AN APPRAISAL OF THE 1992 PRELIMINARY PERFORMANCE ASSESSMENT FOR THE WASTE ISOLATION PILOT PLANT

Environmental Evaluation Group
New Mexico

September 1994

This is the Environmental Evaluation Group's (EEG) appraisal of the 1992 performance assessment for the Waste Isolation Pilot Plant. Performance assessments have been performed by Sandia National Laboratories for the U. S. Department of Energy to predict the long-term safety of the Waste Isolation Pilot Plant. The 1992 Performance Assessment, entitled *Preliminary Performance Assessment for the Waste Isolation Pilot Plant, December 1992,* is in five volumes:

Figure 1. Comparison of mean CCDFs from the EEG scenario of direct ground discharge for all actinide solubilities set at 10^{-3}, 10^{-5}, and 10^{-7} M with Curve 1 from Figure 9-1 of SAND92-0700/4.

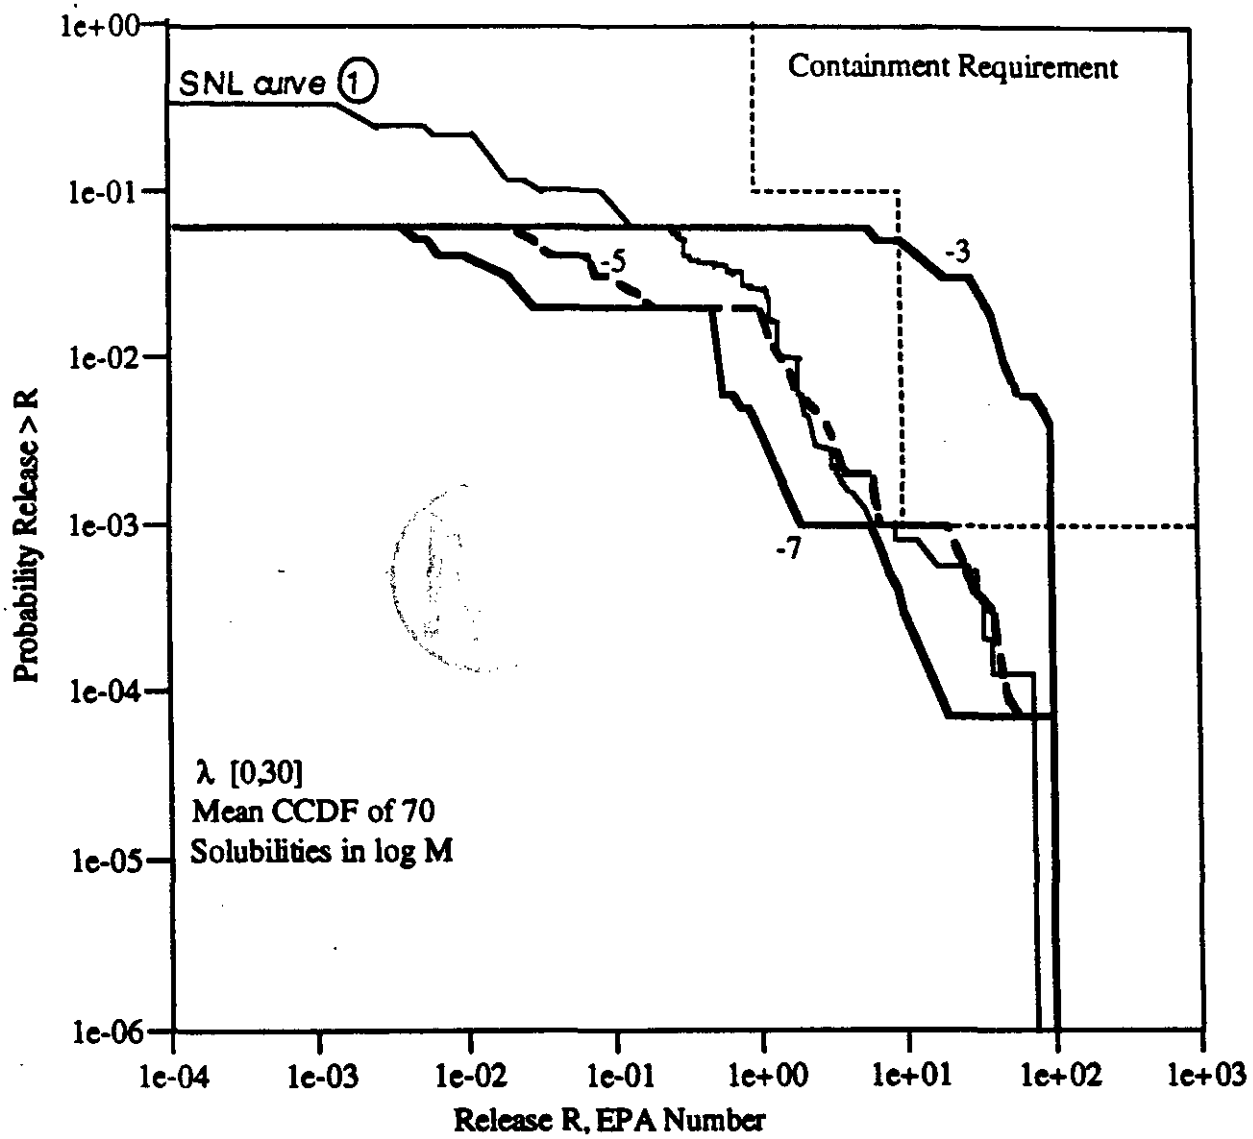
rate, the mean CCDF comes to within a factor of two or three of the USEPA containment requirement [vol. 4, Fig. 9-1, curve 1]. This suggests several vectors of CCDF lie in the zone of violation of the containment requirement. This mean CCDF is not as conservative as it may appear because subjectively elicited solubilities are incorporated. The non-conservative basis of curve 1 in Figure 9-1 is illustrated in Figure 1. Using BRAGFLO-calculated brine flow from the repository up to the Culebra (70 vectors for both the E2 and E1E2 scenarios), all actinide solubilities at 10^{-3}, 10^{-5} and 10^{-7} M, and the human intrusion rate sampled uniformly between 0 and 30 boreholes/km^2/10,000 years, the mean CCDFs are shown in Figure 1, along with curve 1 from Figure 9-1 (vol. 4). If the extremely low subjectively elicited solubilities are **not** used, then the mean CCDF for the case of engineered barriers alone may not meet the containment requirement. See also 14 below.

Recommendation 3.1. As experimental solubility values become available (e.g. Nitsche *et al.*, 1992; 1993), use them in performance assessment.

Figure 3. Reproduction of a viewgraph shown to the Future and Markers Panels by SNL, showing SNL's concept of the elicitation.

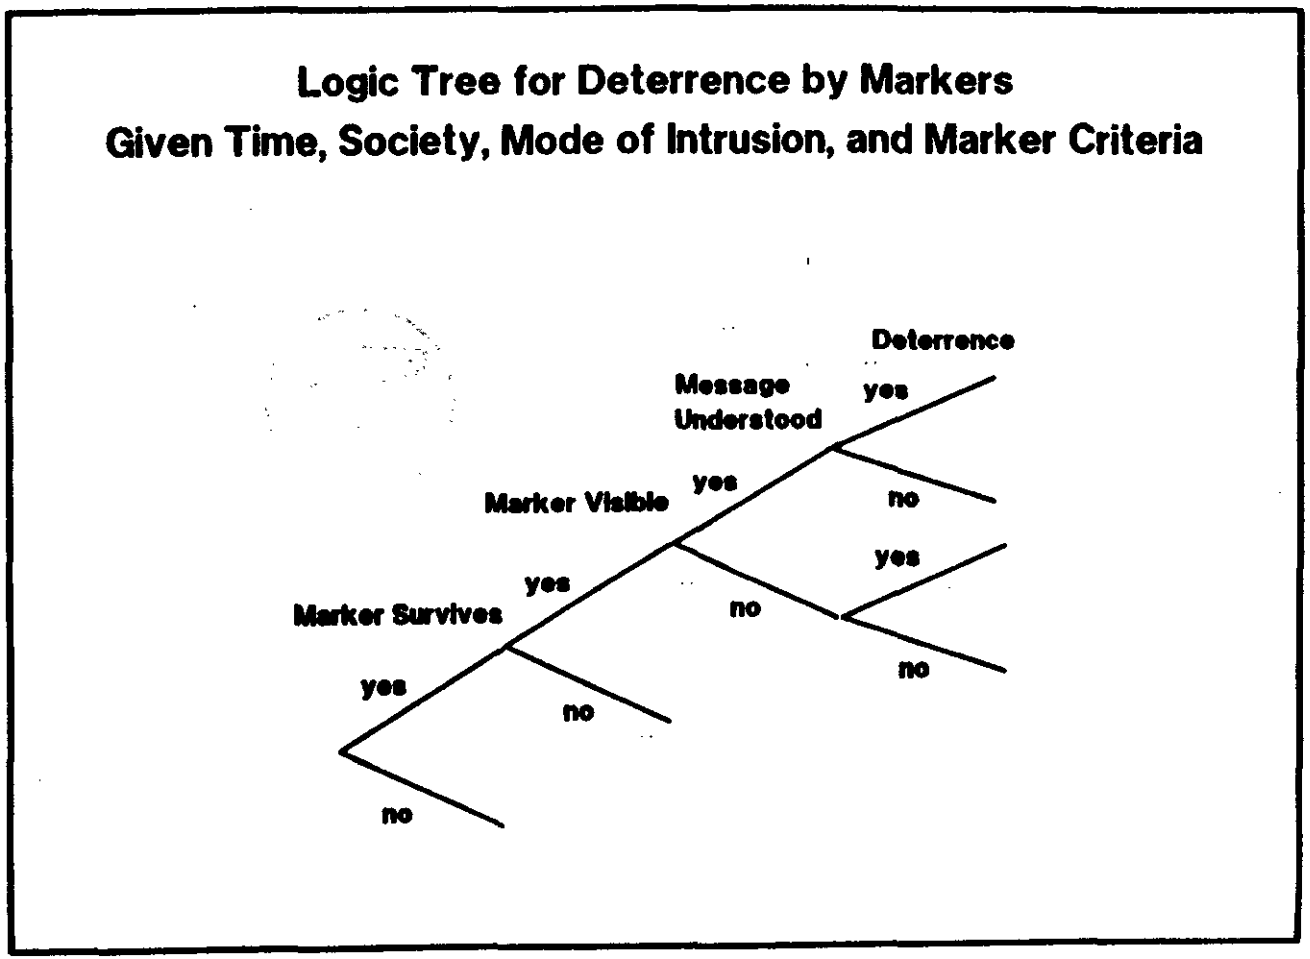
The USDOE response to the preliminary comments from the EEG referred to a SNL viewgraph (Figure 3) entitled "Logic Tree for Deterrence by Markers Given Time, Society, Mode of Intrusion, and Marker Criteria." If one defines each of the branches in Figure 3 as p_1, p_2, p_3 and p_4, then deterrence is

Figure 4. EEG's suggestion for a rate of human intrusion by drilling.

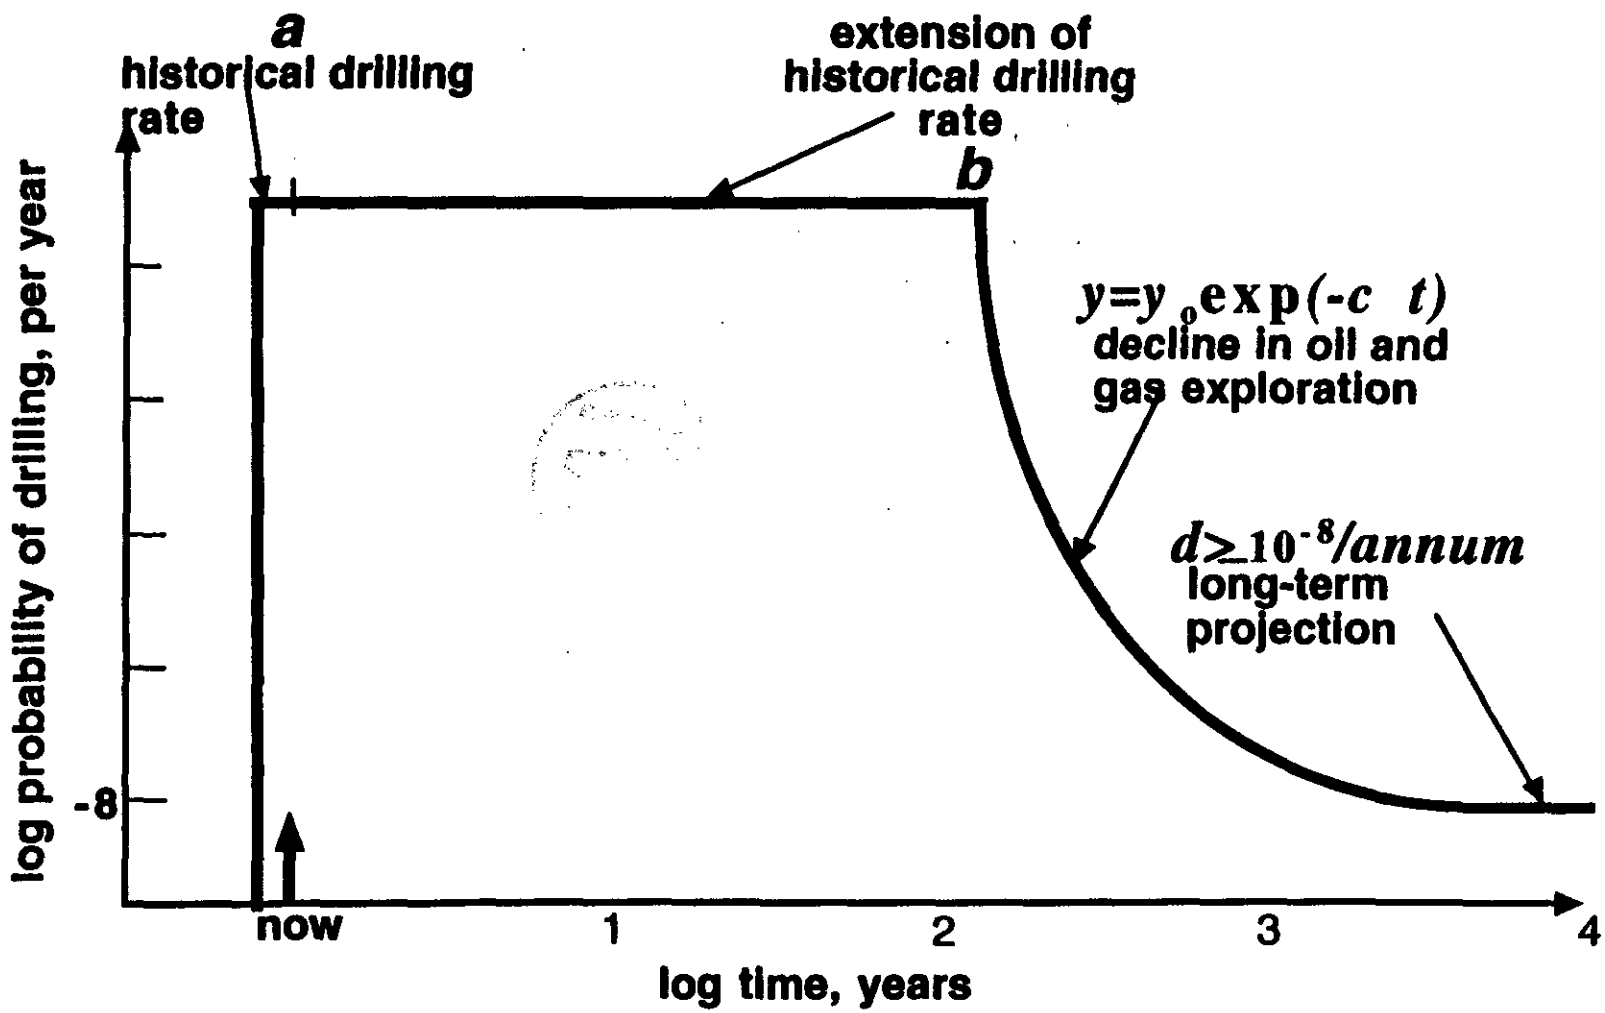
Figure 4 shows what EEG believes the exploratory drilling rate to be in any specific area, and illustrates the evolution of oil and gas drilling as a function of time.

Figure 4 shows a historical record of drilling in this area, a known rate, a holes per area per year, $a > 0$. The U.S. Environmental Protection Agency's guidance (40 *CFR* 141, Appendix C) of thirty boreholes per kilometer^2 over 10,000 years is such a rate.

For the long-term, there should be a rate of intrusion that is

(a) non-zero; and

(b) above the USEPA threshold probability for events and scenarios to be considered, or 10^{-8} per year. Call the rate d holes per area per year, $d \geq 10^{-8}$ per year.

Figure 9. Oil and gas wells near the WIPP, October 1993.

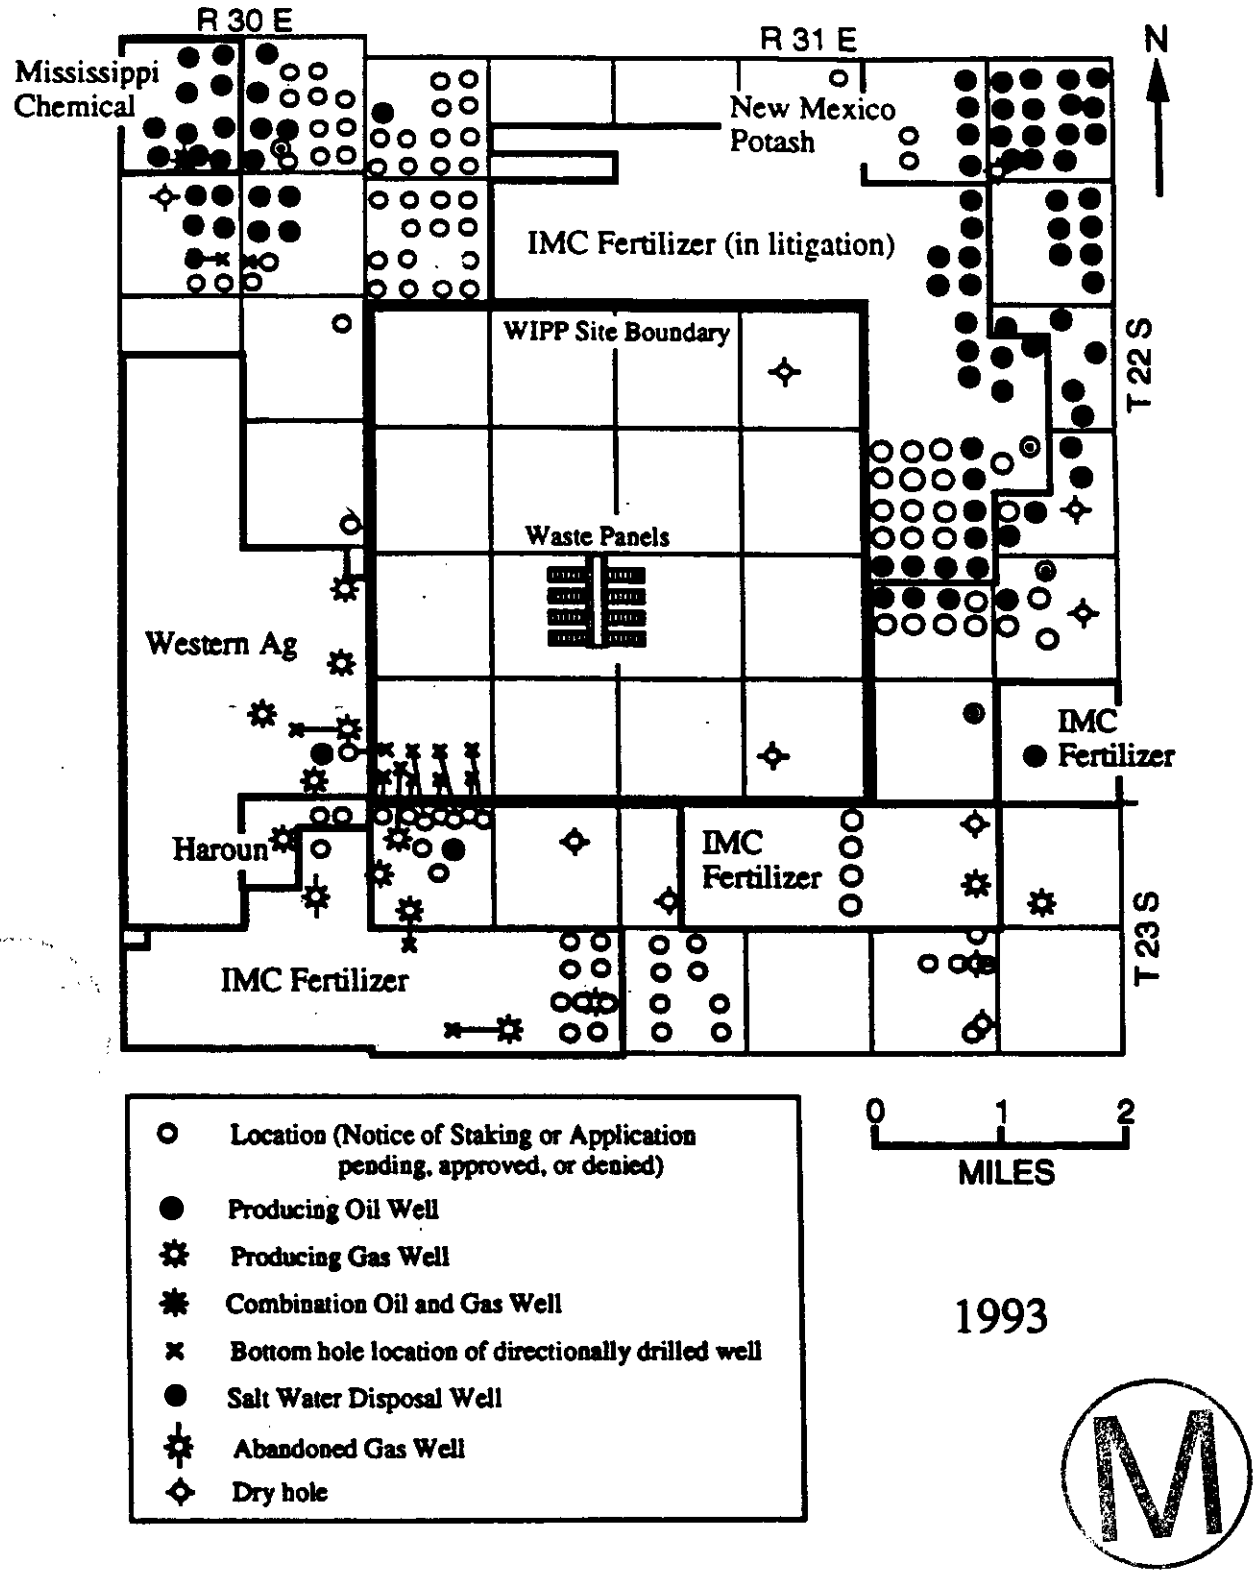
Figure 9 shows the number of oil wells near the WIPP site in October 1993. Table II shows the recent history of wells in the same locations. Figure 9 and Table II belie the suggestion that there is no economically recoverable oil near WIPP. Actually, SNL did tell the panelists about oil and gas production near the WIPP. Figure 10 is a viewgraph shown to the panels by the speaker on cultural resources. That the panelists did not raise questions suggests that

Figure 11. EEG scenario of direct discharge of contaminated brine to ground surface.

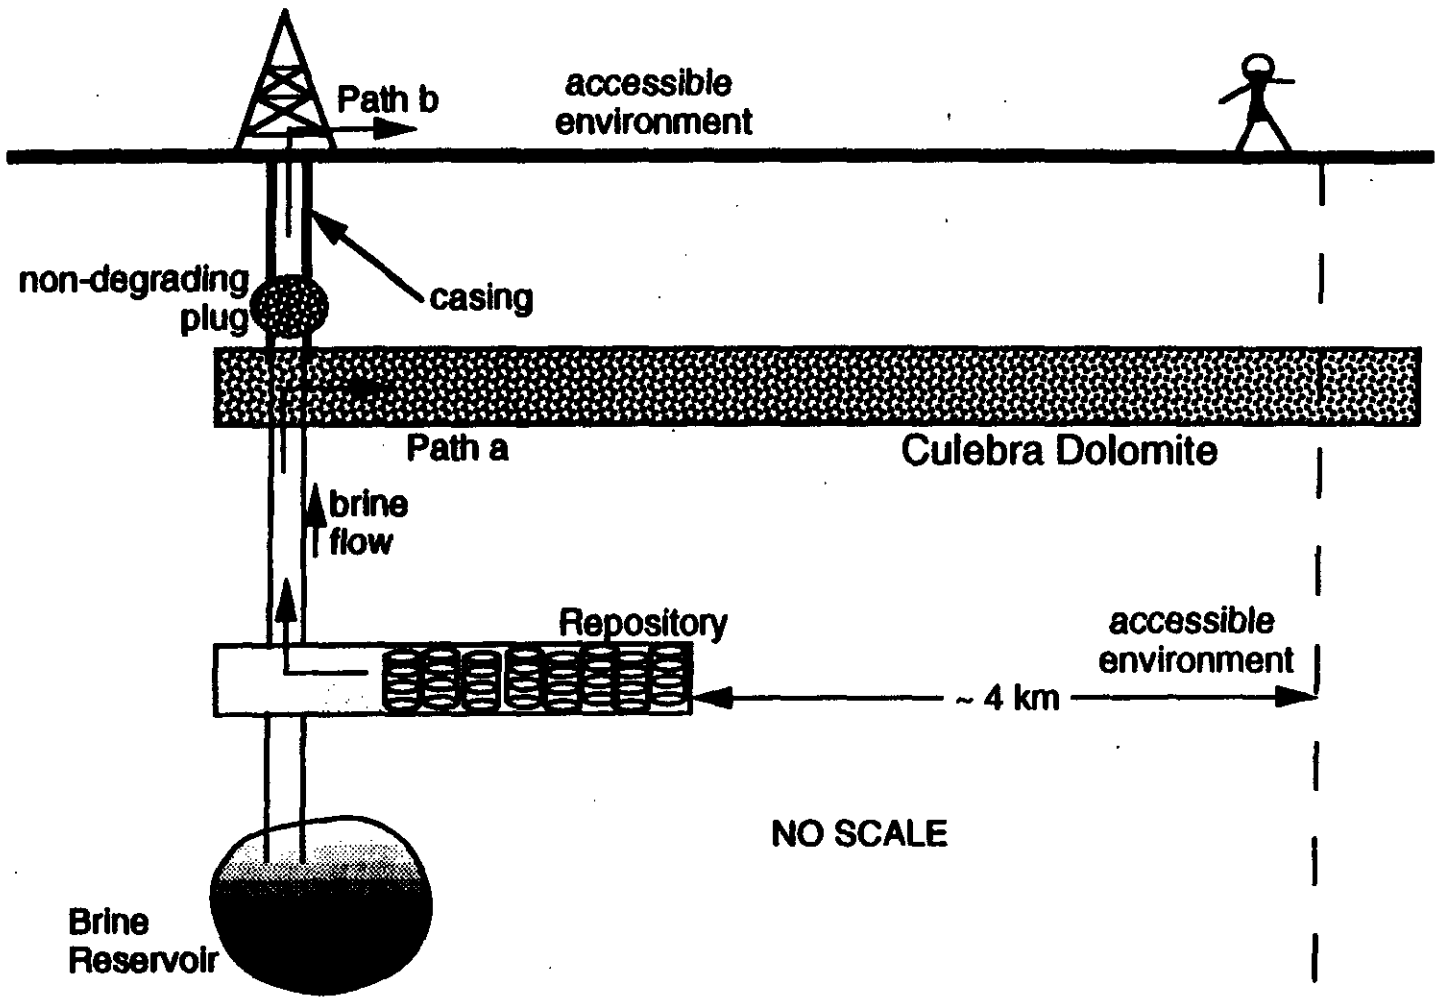
include a degrading plug, with the contaminated brine reaching the accessible environment at the ground surface, release Path b in Figure 11. Current oilfield practice in the Delaware Basin is to case the wells down to the top of the salt deposits, preventing contaminated brine from entering the water-bearing zones above the salt. Figure 12 shows CCDFs for the following conditions:

Recommendation 11.3 Provide results of the abovementioned analyses, and include contaminated brine flow to the ground surface in future versions of human intrusion scenarios.

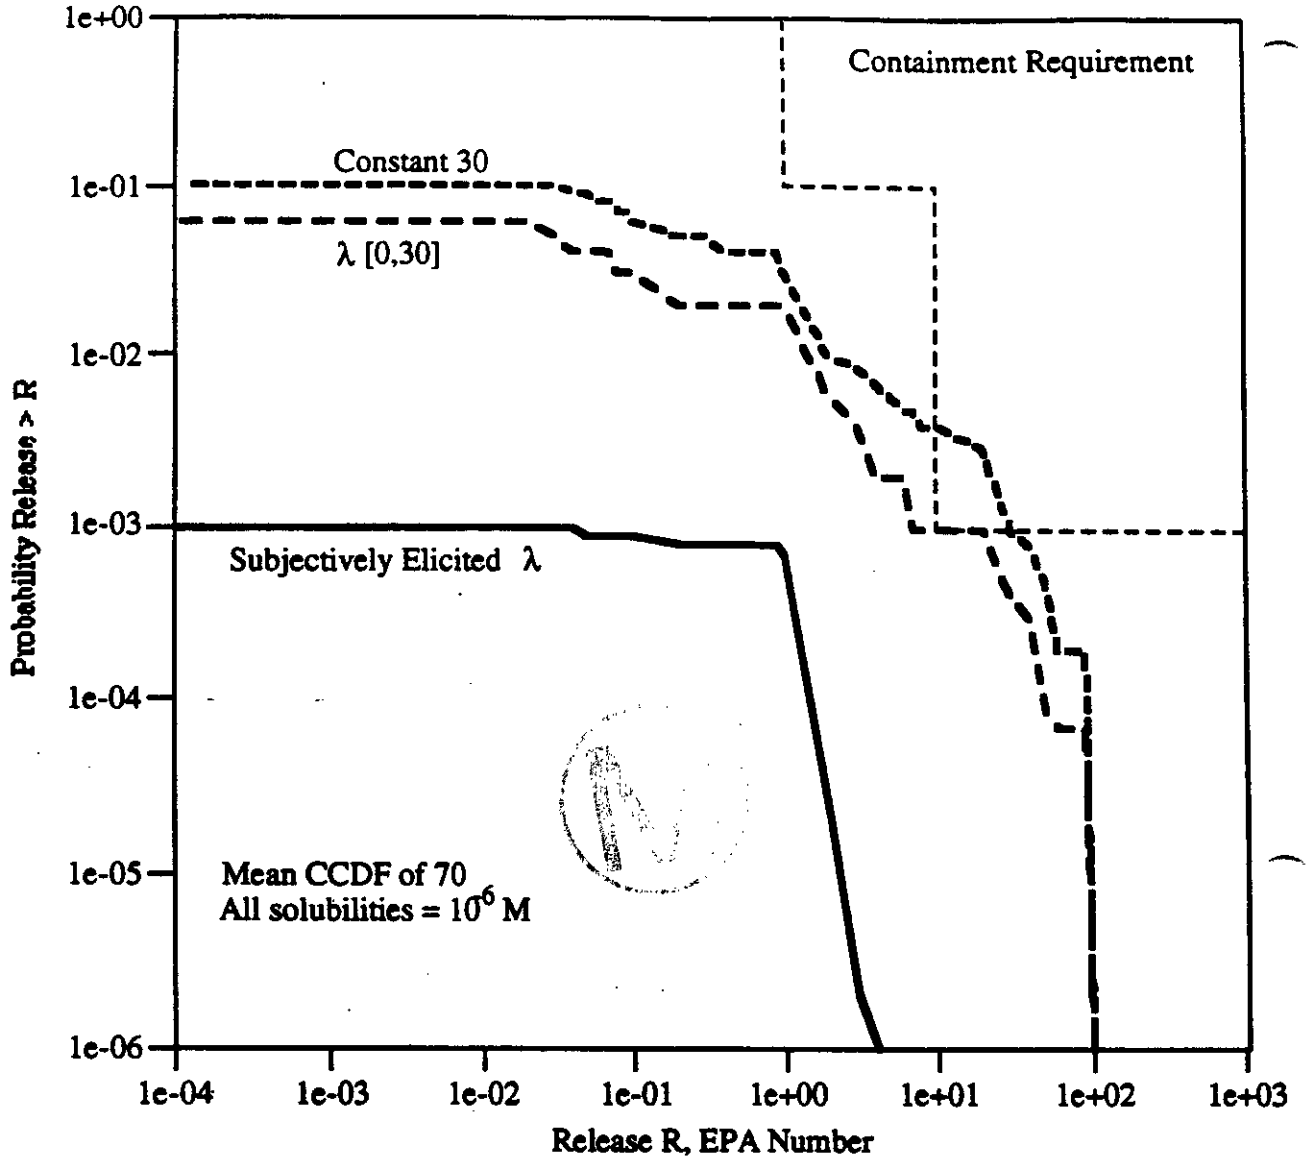
Figure 12 shows that if all actinide solubilities are 10^{-6} M, the mean CCDF of 70 would be very close to violating the containment requirement, unless subjective probabilities are used.
